LAND USE APPLICATION SUMMARY

Property Location: 1500-1520 Johnson St NE and 1601 Fillmore St NE
Project Name: Northeast Park Recreation Building
Prepared By: Shanna Sether, Senior City Planner, (612) 673-2307
Applicant: Perkins + Will
Project Contact: Dave Sheppard
Request: To construct a new recreation building in an existing public park.
Required Applications:

Preliminary Development Review Report

Tracking Number:	PDR 1001376
Applicant:	MINNEAPOLIS PARK & RECREATION BOARD 2117 WEST RIVER ROAD MINNEAPOLIS, MN 55411
Site Address:	1520 JOHNSON ST NE 1500 JOHNSON ST NE
Date Submitted:	16-OCT-2015
Date Reviewed:	28-OCT-2015

1 OVERALL SITE PLAN
1/16" = 1'-0"

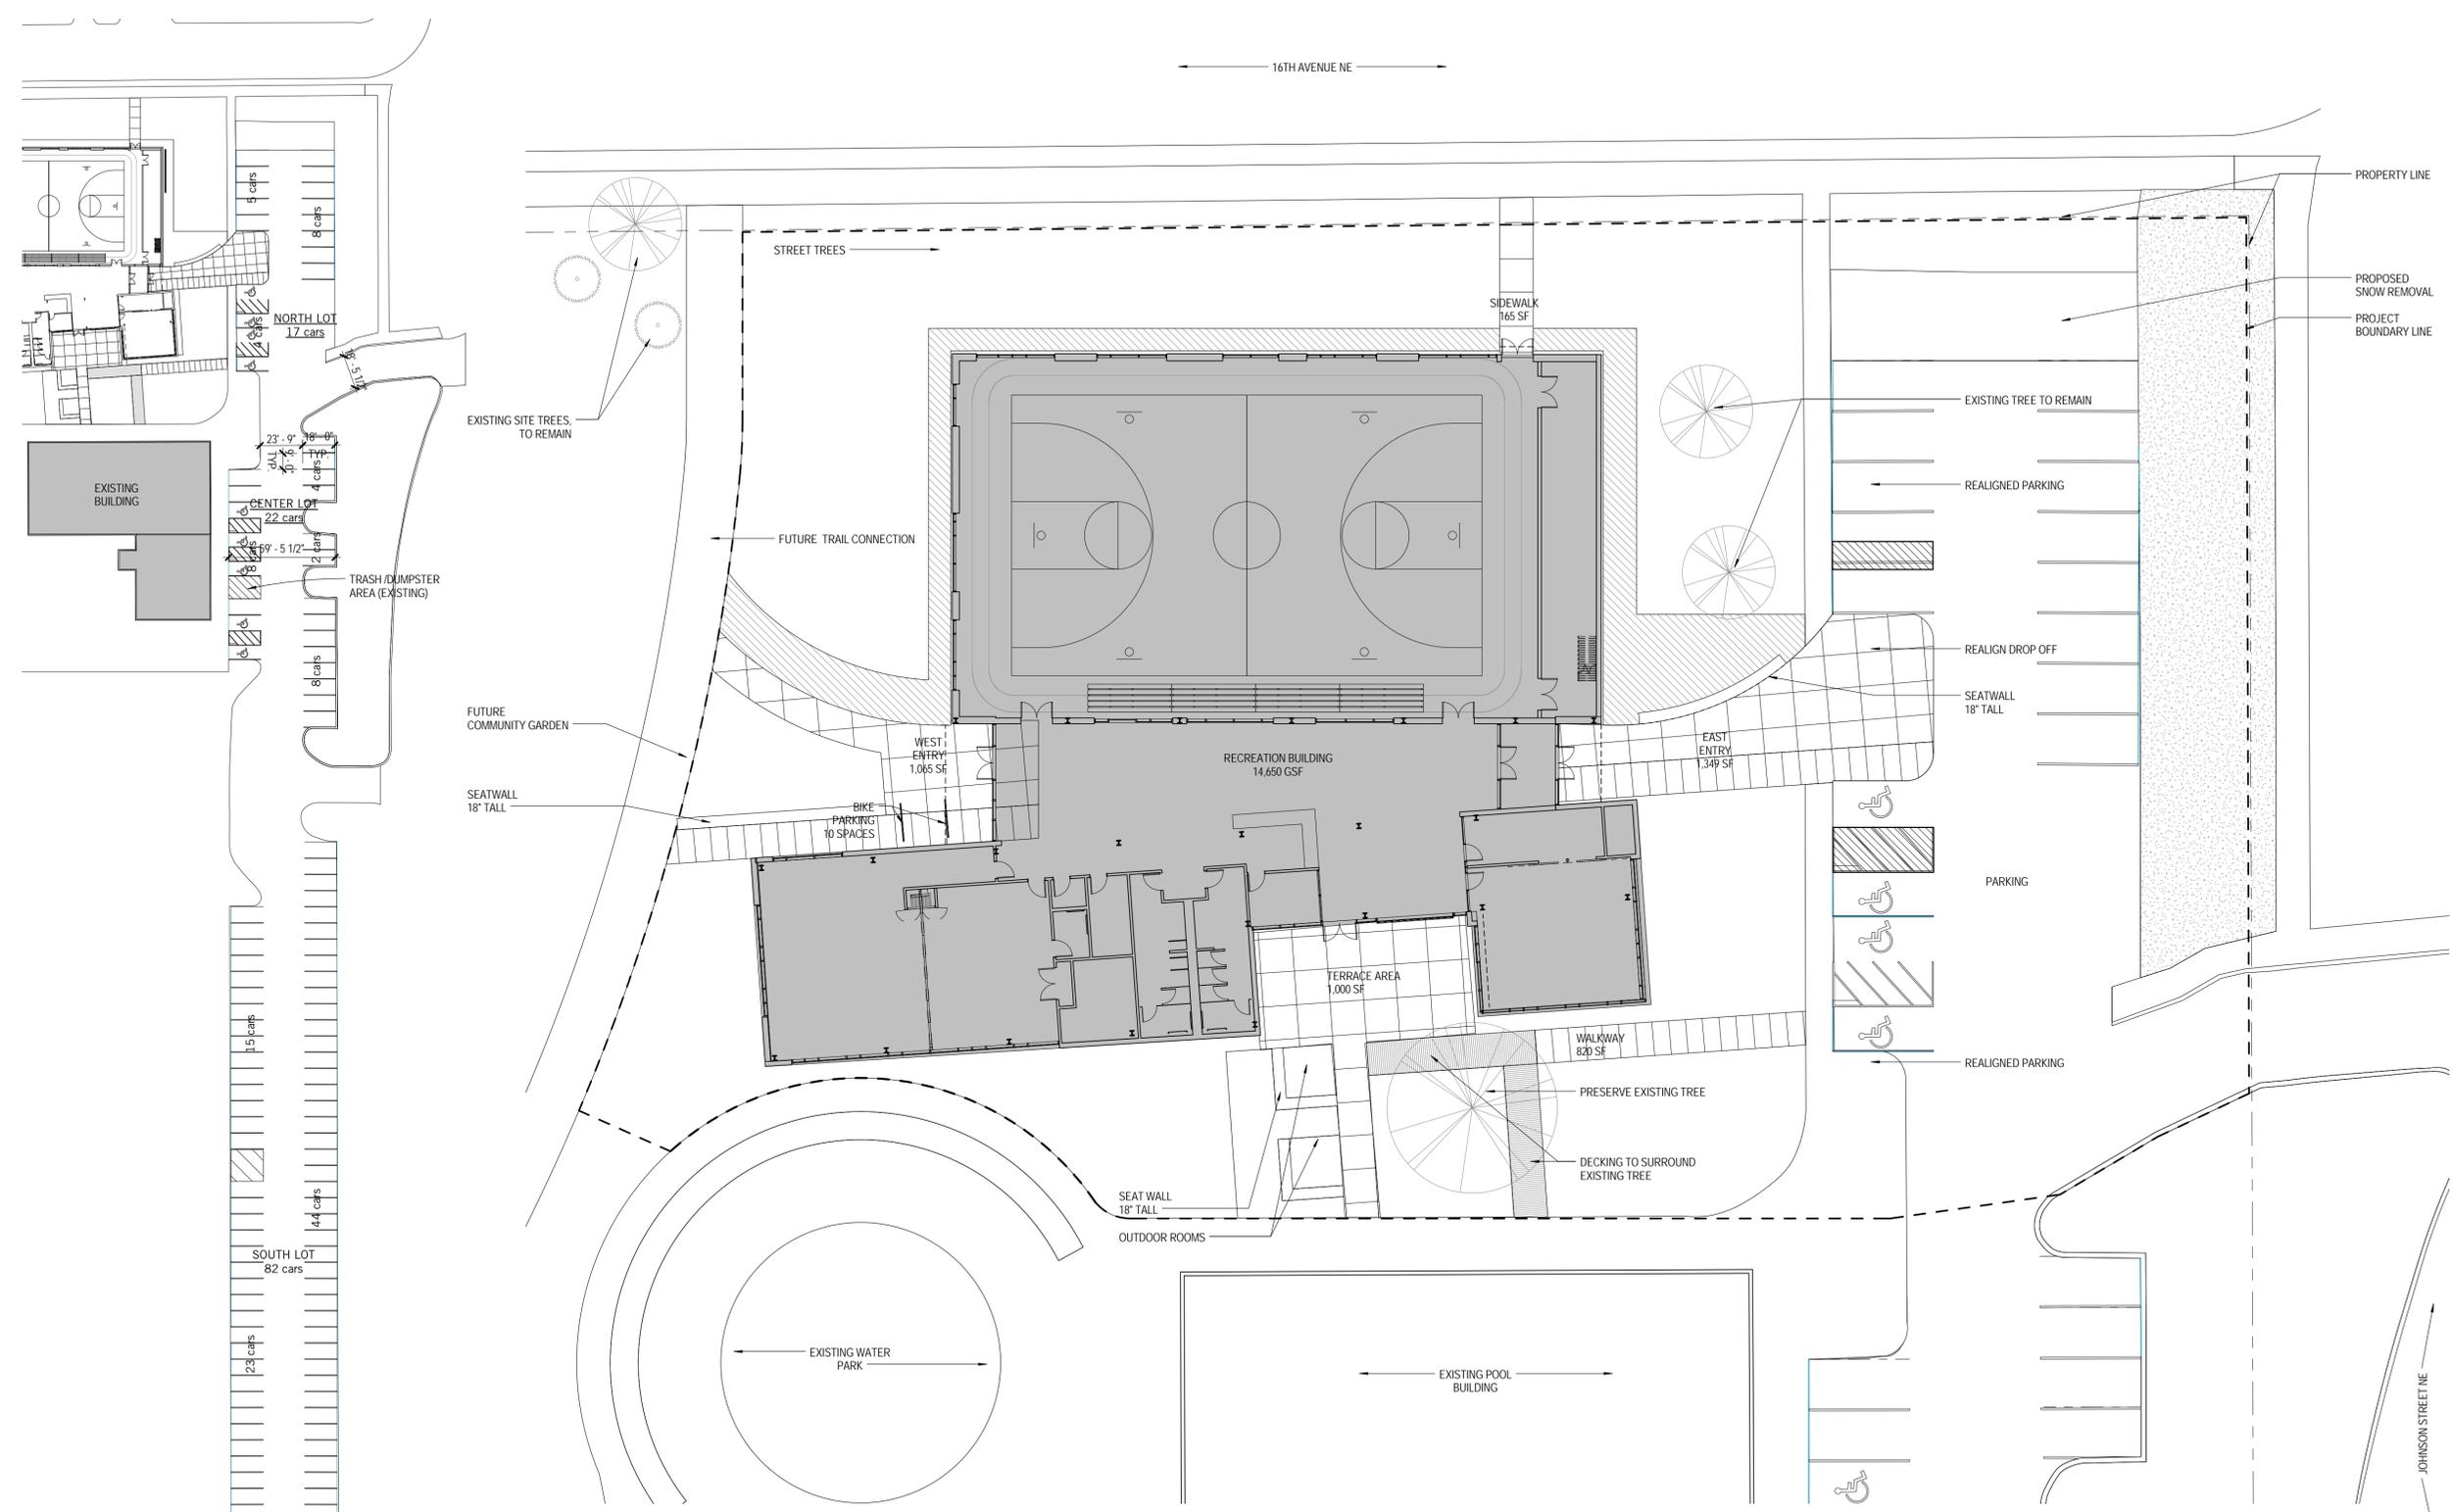
- There is an existing surface parking lot between the front lot line and the proposed structure. The proposed location will require alternative compliance.

- **Building Placement.** The first floor building wall is required to be located not more than 8 feet from the lot line adjacent to Johnson Street NE. The proposed building will be 50 feet from the front property line. The existing parking lot and landscaped yard are between the proposed structure and the front lot line and meeting this requirement is impractical. Therefore, staff is recommending that the planning commission grant alternative compliance.

- **Parking Lot Screening:** The applicant is required to provide screening of a minimum 3 feet in height and 60% opaque between the parking area and the public sidewalk and street. The applicant is not proposing any screening of the parking lot. Staff recognizes that the length of the parking lot exceeds 800 feet, however staff is recommending that alternative compliance be granted to significantly reduce the required of trees and shrubs (see below). Staff is recommending that the applicant comply with this requirement.

2. The applicant shall provide screening of the parking lot of at least three feet in height and 60% opaque, between the parking lot and Johnson St NE, as required by section 530.170 (b) of the zoning code.

1 SOUTH ELEVATION
1/8" = 1'-0"

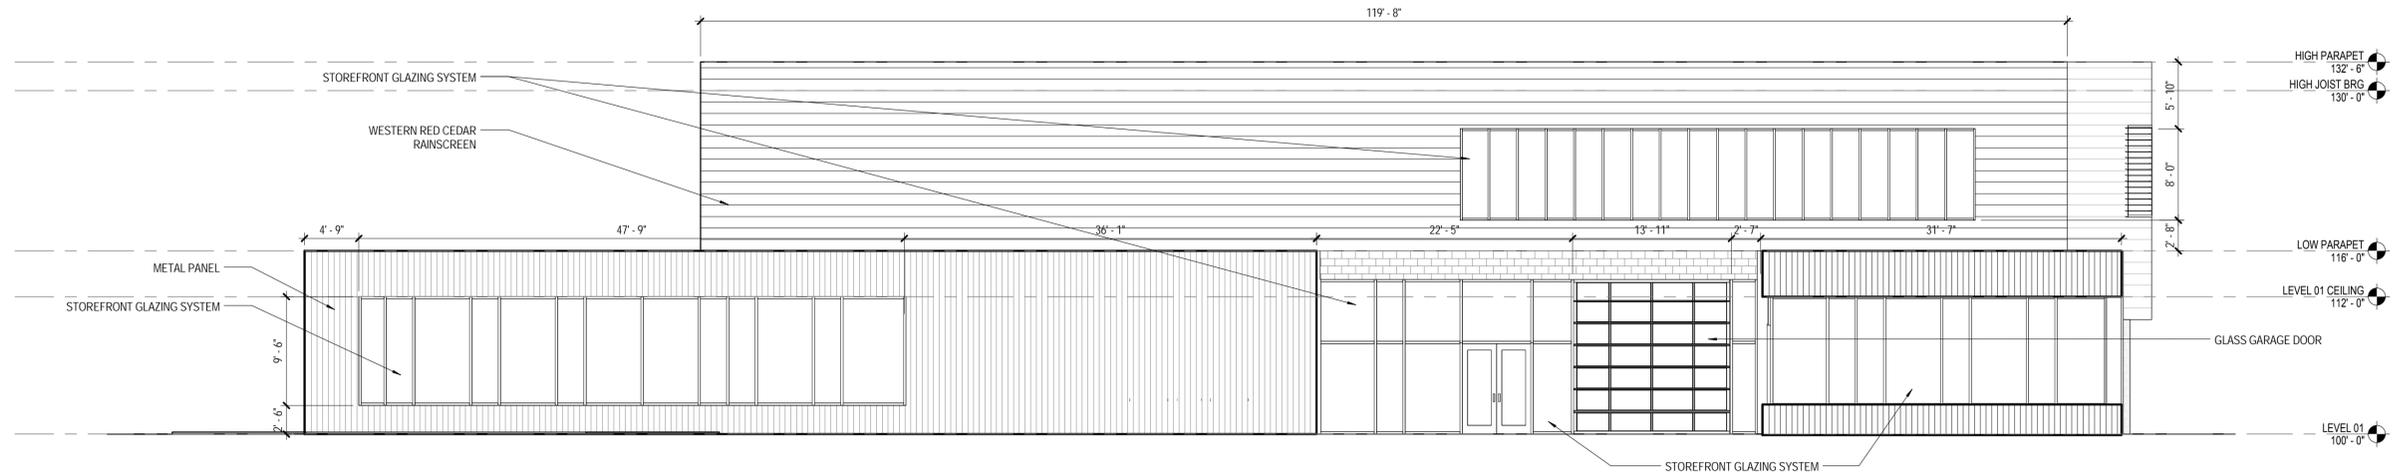
- There are several sections of the proposed building with blank, uninterrupted walls exceeding 25 feet in length. The first floor of the east elevation (front) and south elevation has a 66 foot and 42 foot long wall, respectively, without any recesses, projections, windows or change of material. In addition, the upper area of the gymnasium on all four sides has blank, uninterrupted walls exceeding 25 feet in length. The applicant is seeking alternative compliance.

- **Blank Walls.** There are several sections of the proposed building with blank, uninterrupted walls exceeding 25 feet in length. The first floor of the east elevation (front) and south elevation has a 66 foot and 42 foot long wall, respectively, without any recesses, projections, windows or change of material. In addition, the upper area of the gymnasium on all four sides has blank, uninterrupted walls exceeding 25 feet in length. The applicant is seeking alternative compliance for these locations. The front elevation on the first floor is the storage area for the gymnasium. The applicant is proposing a landscaped area in this location and staff recommends that the planning commission grant alternative compliance. The first floor on the south elevation is blank due to the bathrooms along this wall. In addition the upper floor is a red cedar rainscreen and is for the upper space for the proposed gymnasium. Staff finds that the design is exceptional and alternative compliance should be granted for the first floor, south façade and the upper floors, with the condition that the applicant provides a combination of perennials, native grasses and shrubs in the proposed planting area between the building and the parking lot.

2 EAST ELEVATION
1/8" = 1'-0"

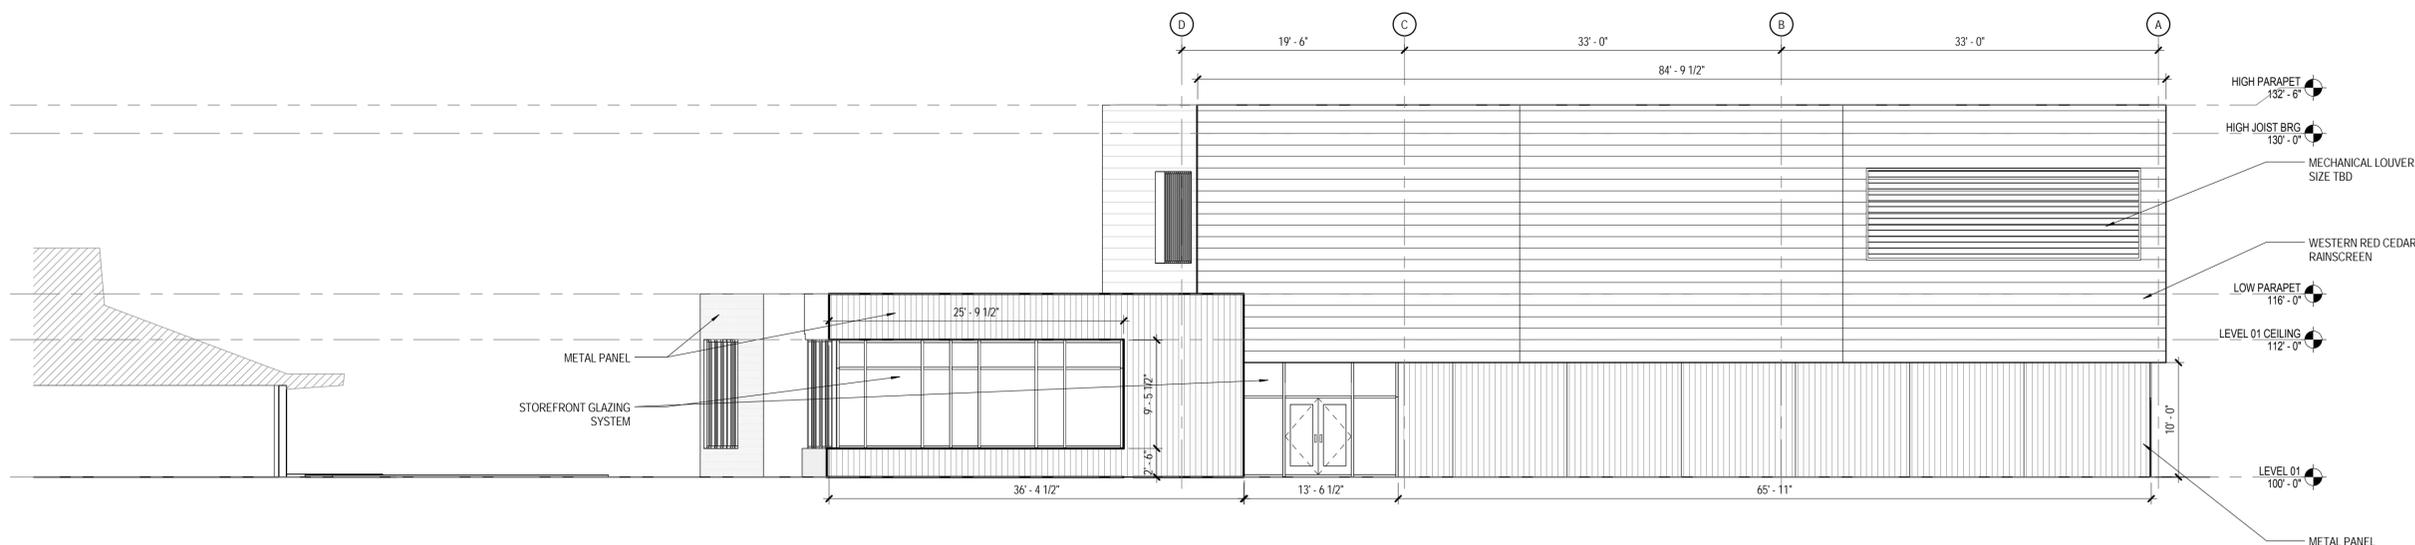
- **Windows.** 24% of the walls on the first floor of the east façade are windows where 30% are required. 10% of the walls of the upper floors facing east and north are required to be windows and none are provided. The front elevation on the first floor is the storage area for the gymnasium. The applicant is proposing a landscaped area in this location and staff recommends that the planning commission grant alternative compliance. In addition the upper floor is a red cedar rainscreen and is for the upper space for the proposed gymnasium. Staff finds that the design is exceptional and alternative compliance should be granted for the first floor, south façade and the upper floors, with the condition that the applicant provides a combination of perennials, native grasses and shrubs in the proposed planting area between the building and the parking lot.
